SERVICE BULLETIN

MAINTENANCE OF WAY EQUIPMENT					
DATE:	8-1-2001			BULLETIN NO:	01-007
TITLE:	2004316 RETURN LINE MANIFOLD SERVICE GROUP				
RATING:		ALERT (Potential Problem)	X	INFORMATION (Action Is Optional)	
		DIRECTIVE (Action Is Required)		PRODUCT IMPROVEMI (Enhance Product)	ENT
PRODUCT SE	ERIES / M	ODEL: 6700S TAMPE	RS		
SERIAL NO:	Models 151871 and Higher				
SUMMARY:	The two screws that hold the return line manifold to the frame of the machine have broken on occasion due to hydraulic impulses in the return line. This Service Group adds two additional mounting screws to the manifold.				
OPERATIONA		T: To eliminate the pose manifold.	sible brea	akage of the mounting scr	ews on the

SERVICE GROUP INSTALLATION - See Figure 1

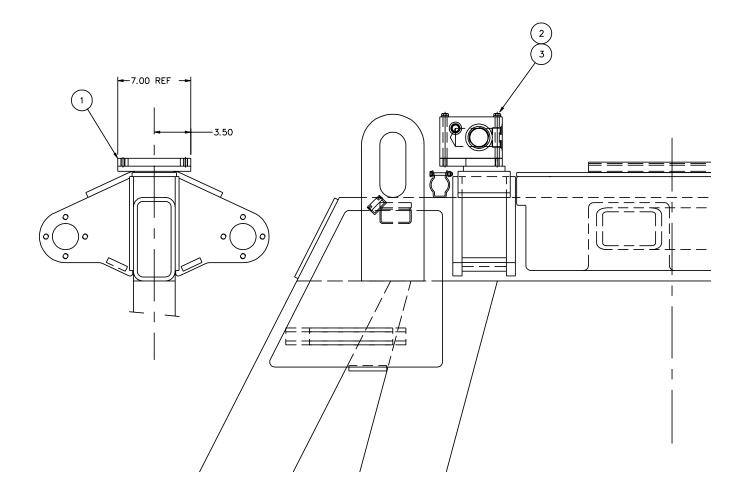
- Removing the existing return line manifold.
- Reworking the existing return line manifold by drilling two additional mounting holes.
- Welding a new mounting bracket onto the machine frame.
- Re-installing the re-worked return line manifold on the new mounting bracket.

- 6. Weld the new mounting plate (1) onto the machine frame per the dimensions and weld symbols as shown.
- 7. Re-install all hydraulic fittings in the reworked return line manifold. Tighten all fittings securely.

- 8. Install the reworked return line manifold to the new mounting bracket (1) using four 3/8"-16 x 4-1/2" long hex head cap screws (2) and four 3/8" lock washers (3). Tighten all cap screws securely.

1003841-2 FIGURE 2 RETURN LINE MANIFOLD RE-WORK

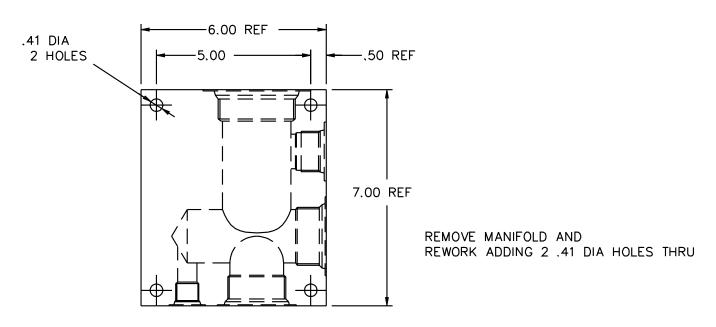
- 4. Rework the existing return line manifold by drilling two 13/32" diameter holes in the manifold per the dimensions shown in Figure 2. Clean the manifold thoroughly of all debris.
